SI B51 06 19
Body Equipment

SERVICE ACTION: REPLACE ROLLER BLIND BUTTON

G07 (X7)			
----------	--	--	--

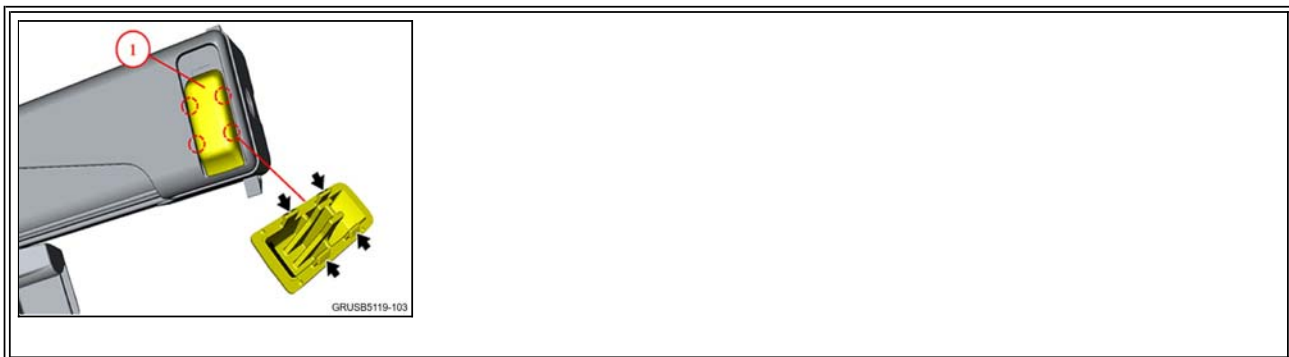
The release buttons for the rear luggage compartment roller cover can break.

Replace both release buttons for the rear roller cover.

- Using a suitable trim bone tool, for example special tool 64 1 020, release the 4 locking mechanisms for the release buttons (1) in the areas shown below.

- Install 2 new release buttons by pressing the button's locking tabs into the roller cover.
